GNRO-2017/00080

SUBJECT: Reply to Notice of Violation – Clarification of Information
Grand Gulf Nuclear Station, Unit 1
Docket No. 50-416
License No. NPF-29

Reply to Notice of Violation – Clarification of Information

Main Steam Line Radiation Monitors

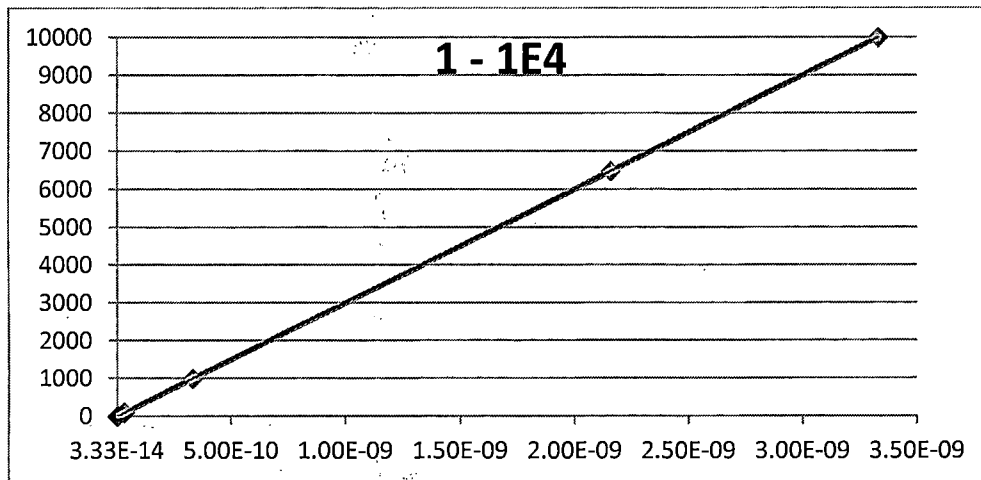
6. When two points are used to establish response to a range of radiation levels, the linear relationship of the detected points needs to be stated and supported by evidence.

Linearity applies to the Main Steam Line Monitors only. Two radiation source calibration data points are plotted on the electronic calibration results line.

The CALIBRATE function of the NUMAC Logarithmic Radiation Monitor checks the internal calibration sources to external standards and allows the user to initiate an internal and automatic calibration sequence. The plant surveillance procedure 06-IC-1D17-R-1002 validates that the radiation monitors are indicating within the acceptable ranges. The radiation calibration section of 06-IC-1D17-R-1002 validates the detector response is within the allowable tolerances.

Graph with measured responses:

Amps	mR/hr
3.33E-13	1
3.33E-12	1.00E+01
3.16E-11	9.50E+01
3.33E-11	1.00E+02
3.33E-10	1.00E+03
2.16E-09	6.48E+03
3.33E-09	1.00E+04
